**U.S. DEPARTMENT OF ENERGY
BROOKHAVEN NATIONAL LABORATORY
CERCLIS Number NY7890008975**

**OPERABLE UNIT III
EXPLANATION OF SIGNIFICANT DIFFERENCES**

February 8, 2005

TITLE:
**MAGOTHY AQUIFER PLUME
Alternative 2-STARTING TVOC
CONCENTRATION (PPB)**

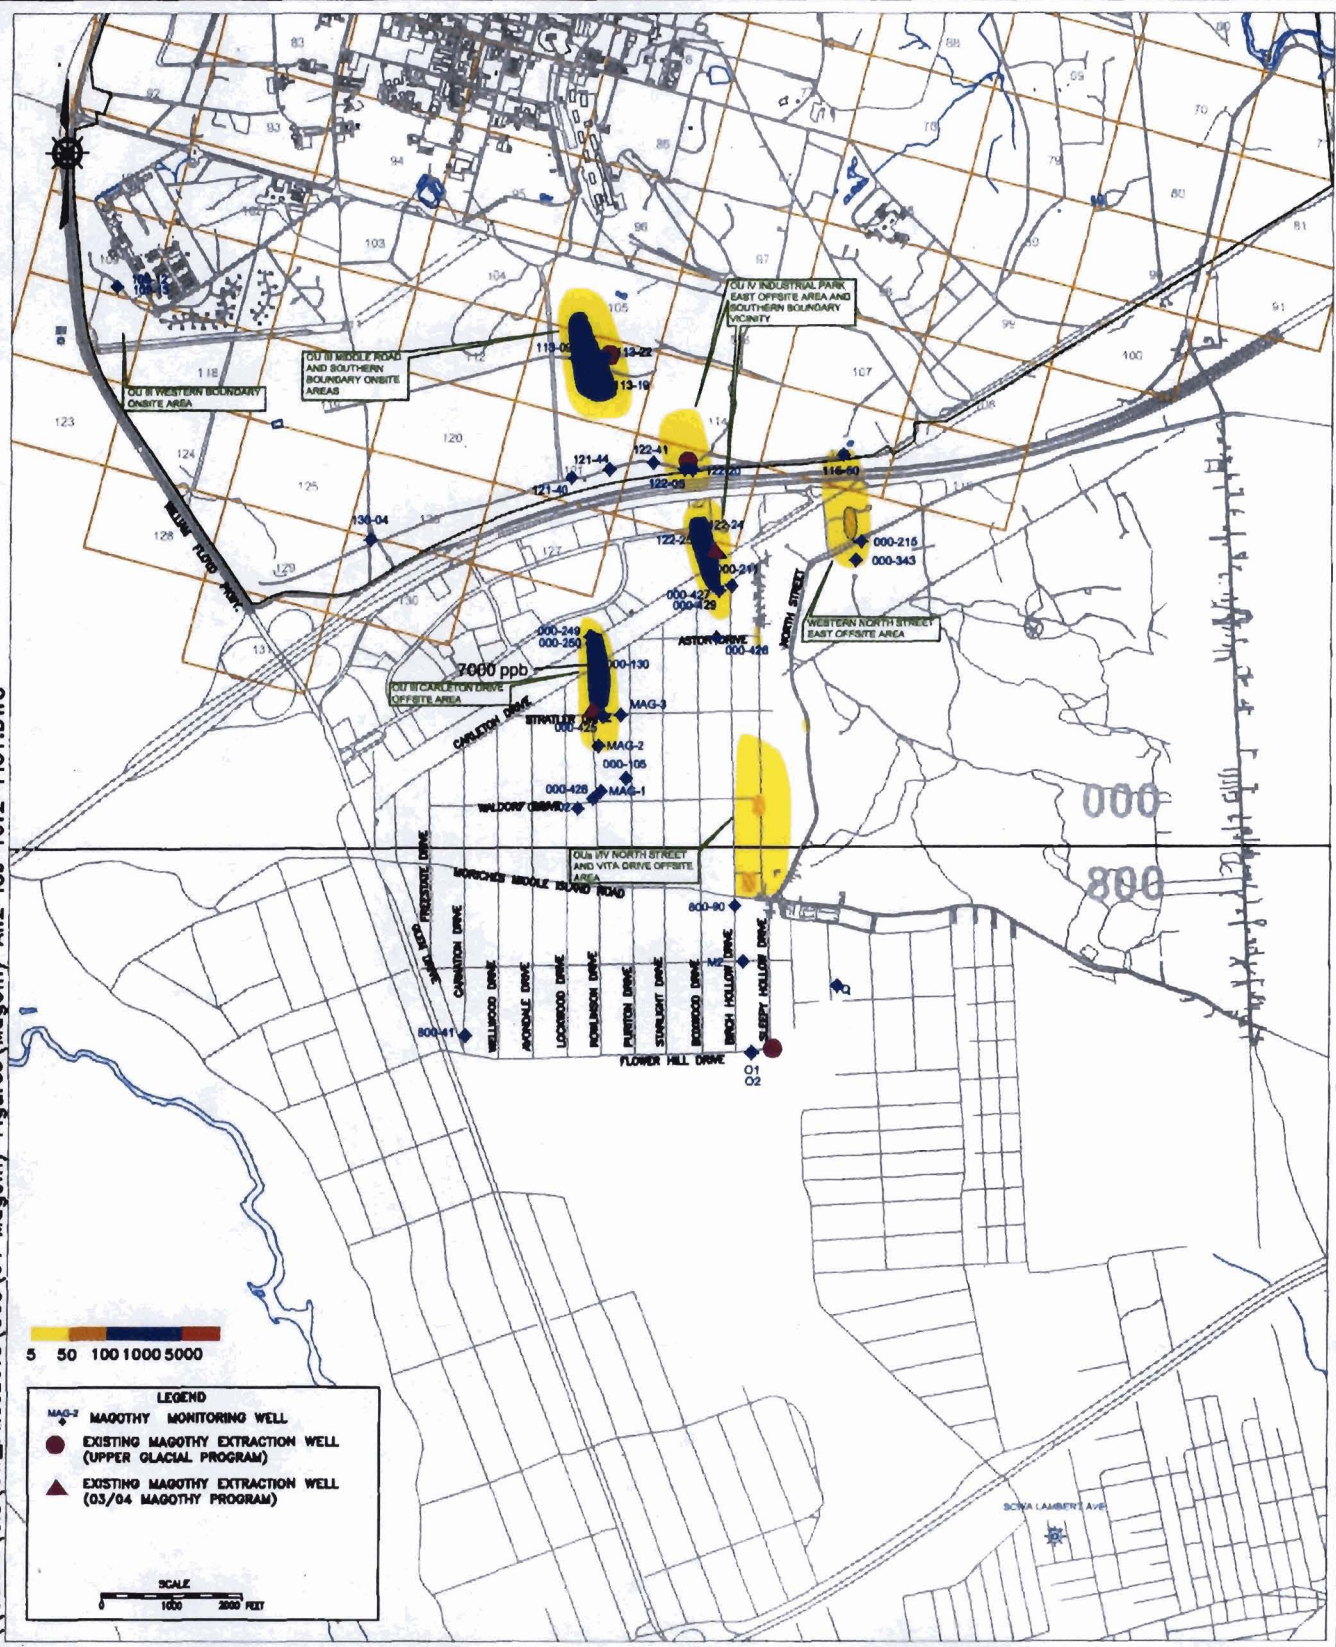
The OU III ROD does not identify a remedy for the Magothy Aquifer. As a result of supplemental characterization and analyses completed pursuant to this ROD, this ESD adds a remedy for the Magothy Aquifer.

The DOE's proposed remedy adds two Magothy Aquifer extraction wells to the three wells that have already been installed at the Magothy Aquifer/Upper Glacial Aquifer interface in connection with other groundwater treatment systems. This remedy, like most other groundwater remedies included in the OU III ROD, would rely on active treatment assisted by natural attenuation. Based on groundwater modeling, the Magothy Aquifer wells are planned to operate between 5 to 10 years followed by 55 to 60 years of natural attenuation. The duration required to reach drinking standards is 65 years. The total cost of adding this Magothy Aquifer remedy to the OU III ROD is \$2,345,000.

Alternative 2 is the remedy being proposed by the DOE. This remedy includes continued operation of the existing three extraction wells as part of the Upper Glacial treatment systems that provide capture of Magothy contamination. Two additional off-site Magothy extraction wells on Stratler Drive (south of Carleton Drive) and at the Industrial Park East location were recently installed to prevent migration of high concentrations of

TITLE:
**CHEMICAL/ANIMAL HOLES
 Sr-90 2003 PLUME DISTRIBUTION
 OU III Explanation of Significant Differences**

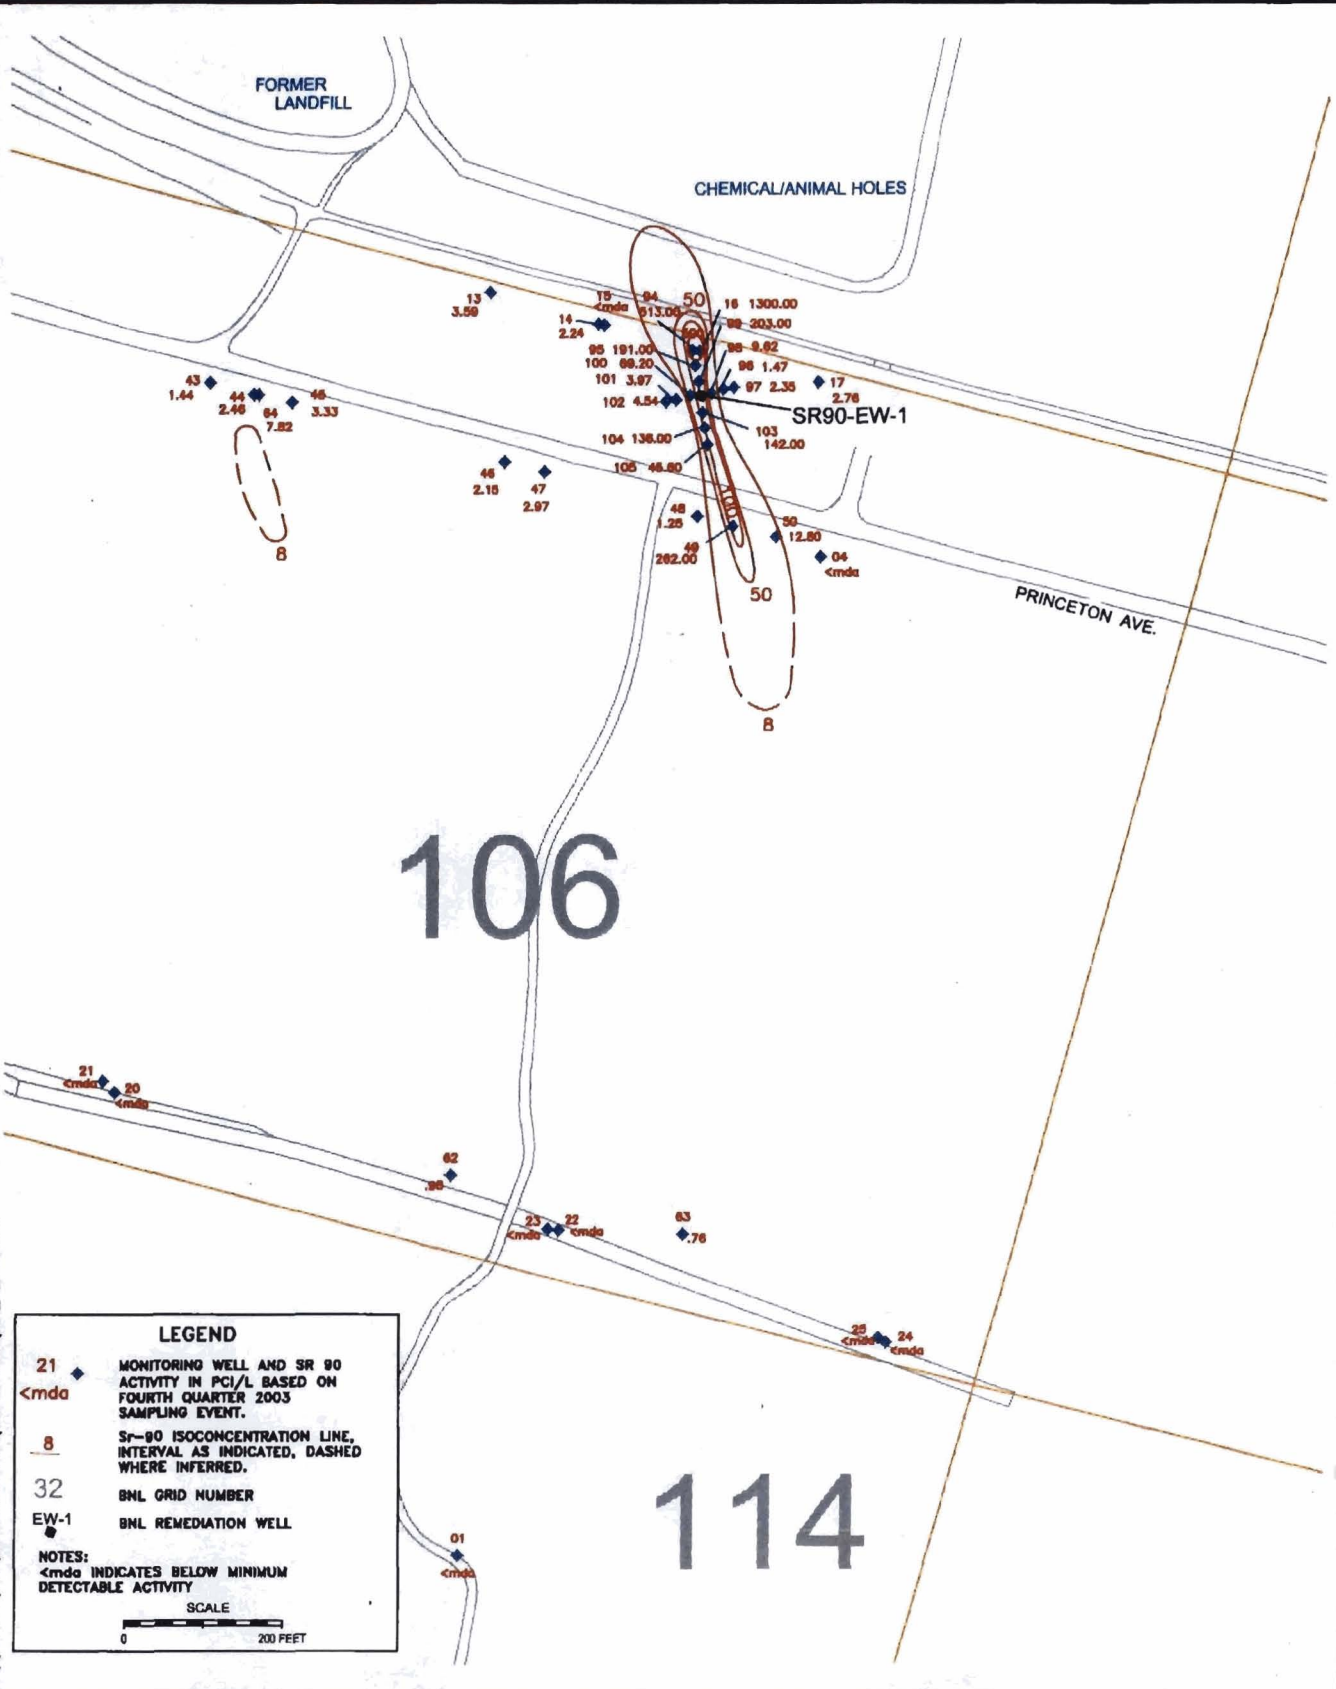
The existing pilot study treatment system would continue to be operated for approximately ten years to actively treat the Sr-90 plume downgradient of the former "Chemical Holes" followed by 30 years of natural attenuation and radioactive decay. The total duration to meet drinking water standards for this plume is 40 years.

DWN: KCK	VT.HZ.: -	DATE: 02/13/04	PROJECT NO.: 07183
CHKD: DBB	APPD: TMB	REV.: 1	NOTES: draft
FIGURE NO.:			3

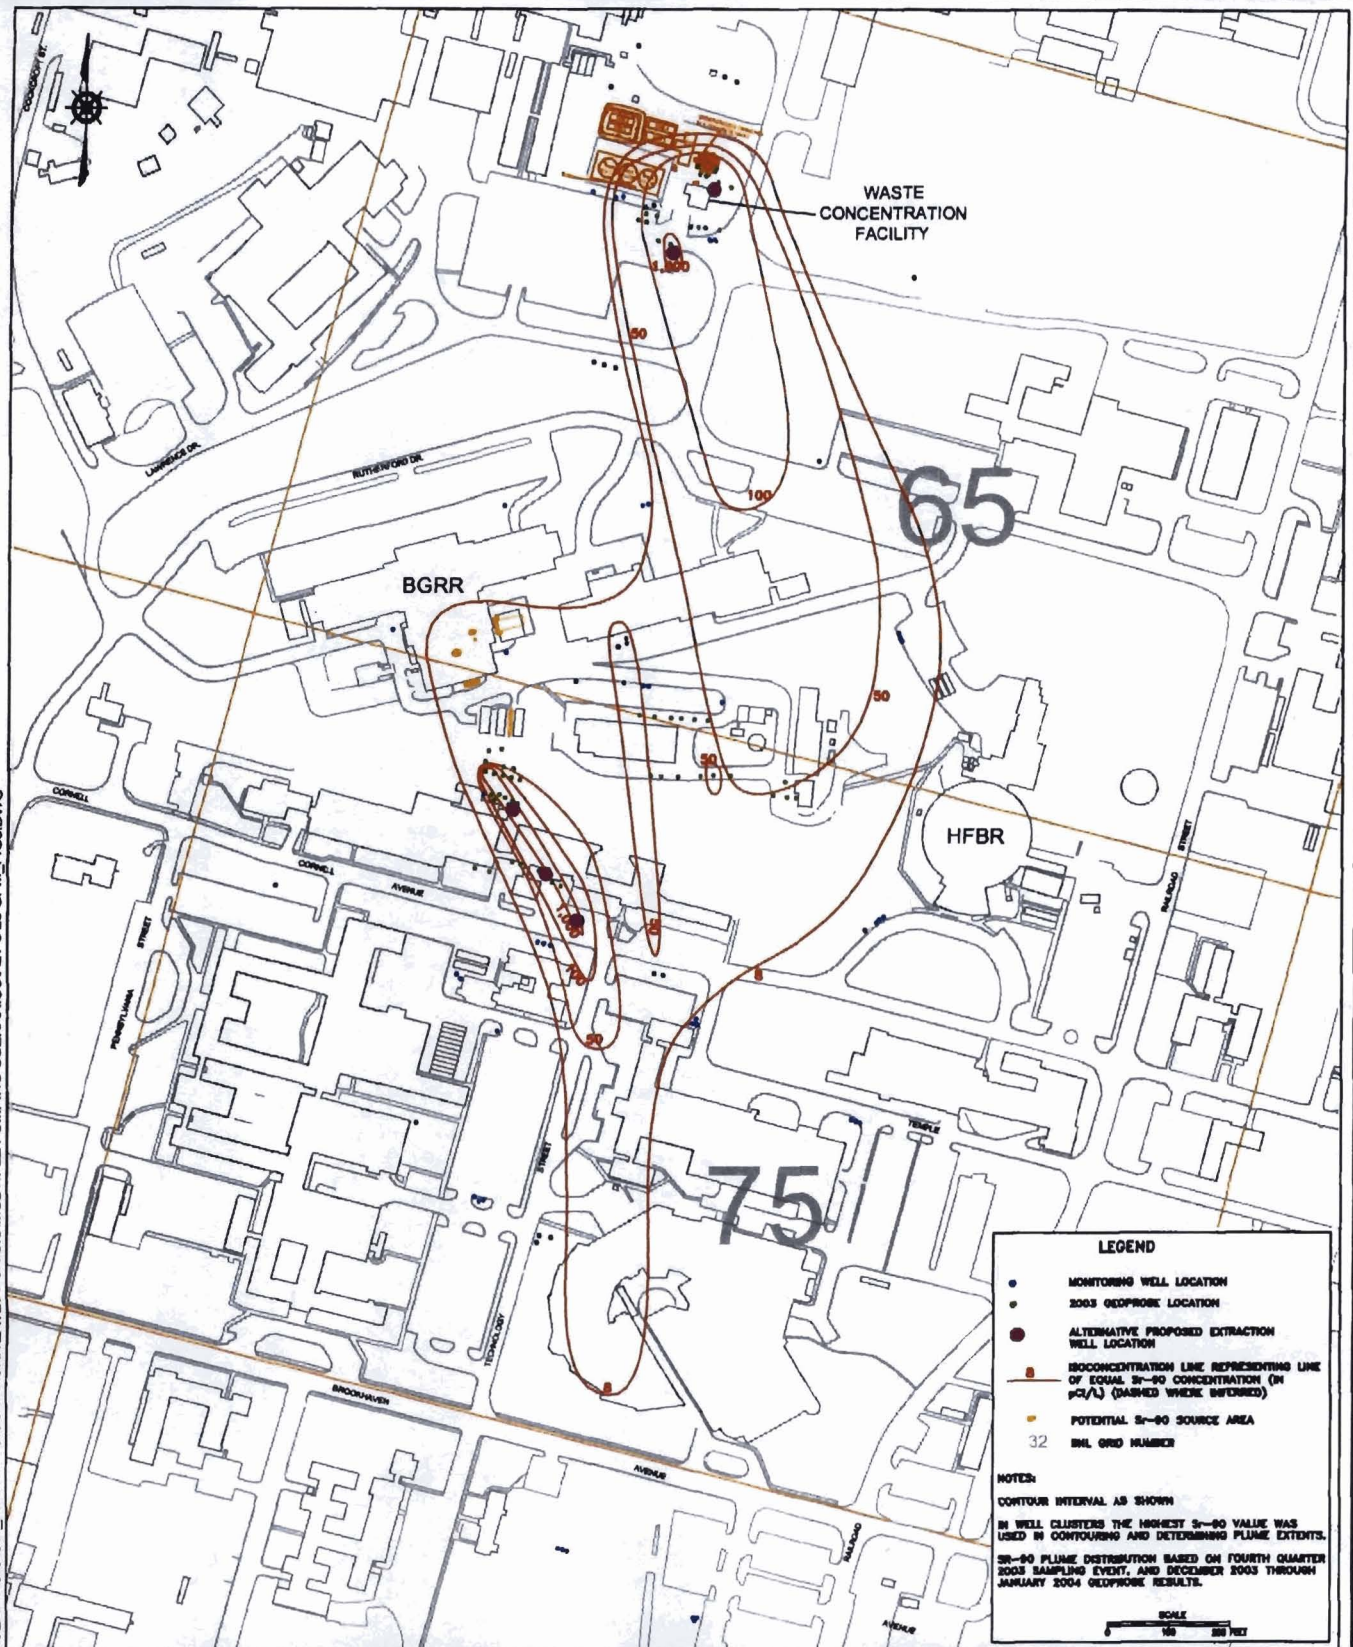
At the BGRR/WCF Sr-90 contamination plume located in the center of the BNL site, DOE proposes to install five extraction wells and groundwater treatment system (ion exchange) using lessons learned during the installation, operation and maintenance of the pilot study treatment system. Based on models using the supplemental characterization data, the system would be operated for a period of approximately ten years, followed by 60 years of natural attenuation and radioactive decay. The total duration to meet drinking water standards is 70 years. Hence, the limiting duration to reach drinking water

standards is 70 years in contrast to the 30-year objective in the OU III ROD. The total estimated life-cycle cost of the Sr-90 remedial alternative is \$14 million.
